# UNITED STATES PATENT AND TRADEMARK OFFICE

10/686,299

<b>Office Action Summary</b>	<b>Application No.</b> 10/686,299	<b>Applicant(s)</b> CHRISTENSON ET AL.	
	<b>Examiner</b> Khiem D. Nguyen	<b>Art Unit</b> 2823

Claims 11-20 are rejected under 35 U.S.C. 102(b) as being anticipated by Schubert et al. (U.S. Patent 5,721,162).

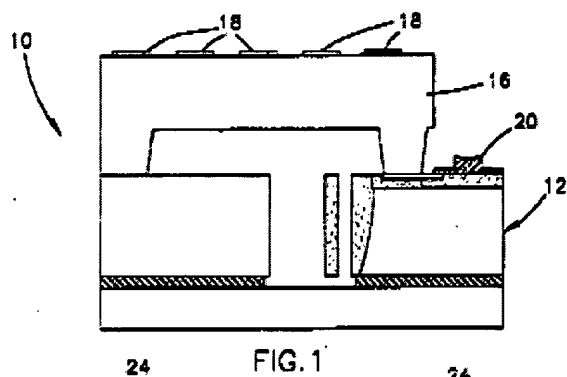
In re claim 11, Schubert discloses a micro-machined device assembly comprising: a device wafer 12 (col. 3, lines 14-24); a capping wafer (col. 2, lines 1-12) bonded on the device wafer to at least partially define a cavity (col. 8, lines 41-57 and FIG. 1);

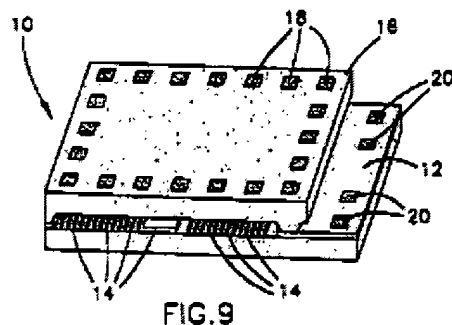
at least one reservoir for receiving a liquid and retaining moisture, the at least one reservoir defining at least one reservoir port (col. 8, lines 41-57) in communication with the cavity; an exposed PN junction diode 14 disposed within the cavity, and adjacent to the at least one reservoir port (col. 4, lines 55-65 and FIG. 9); and

a pair of metal pads 20 connected to the exposed PN junction diode (FIG. 1).

FIG. 3

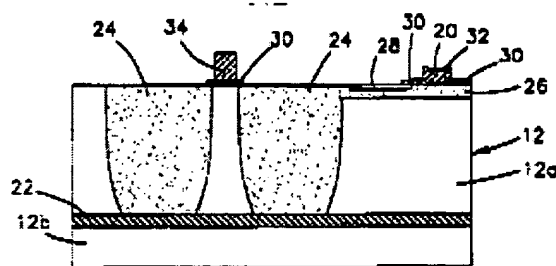
In re claim 18, **Schubert** discloses that the exposed PN junction diode defines a P region and an N region, and wherein one of the pair of metal pads is connected to the P region, and the other one of the pair of metal pads is connected to the N region (col. 4, lines 7-24 and FIG. 3).
